UNITED STATES PATENT AND TRADEMARK OFFICE

APPLICATION NO.	FILING DATE	FIRST NAMED INVENTOR	ATTORNEY DOCKET NO.	CONFIRMATION NO.
10/715,669	11/18/2003	Jerome Glasser		4813

Office Action Summary

DETAILED ACTION

FIG. 49

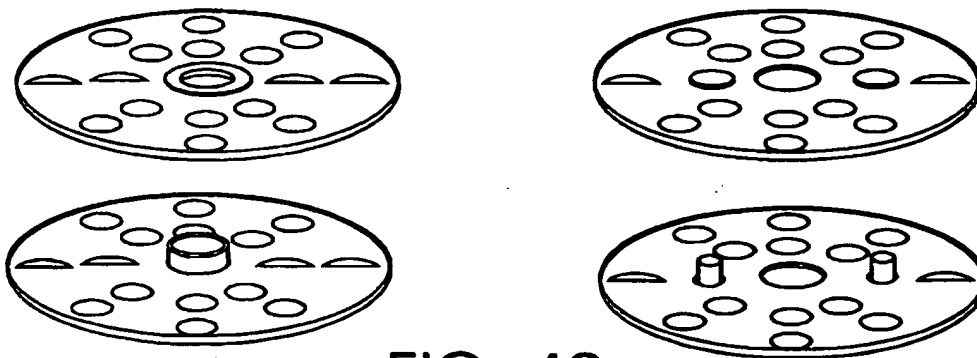
The original disclosure provided no support for the brief description of (new) Fig. 49 (formerly original Fig. 57) regarding the added text of “permitting the joining of a front and back plate at a hub without glue or sonic welding.”

Applicant is required to cancel the new matter in its entirety in the reply to this Office Action.

FIG. 54

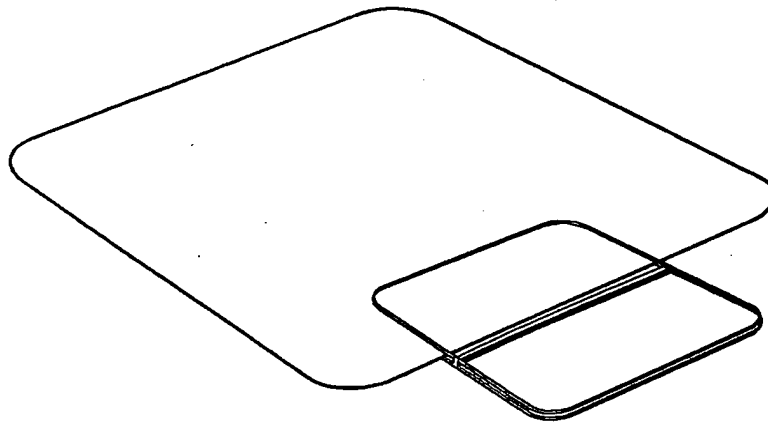
The original disclosure provided no support for the brief description of (new) Fig. 54 (formerly original Fig. 62) regarding the subject matter pertaining to the added underlined text of “NFIG. 54 is the embodiment of NFIG. 53- without tack hole and holding a card-like display item.”
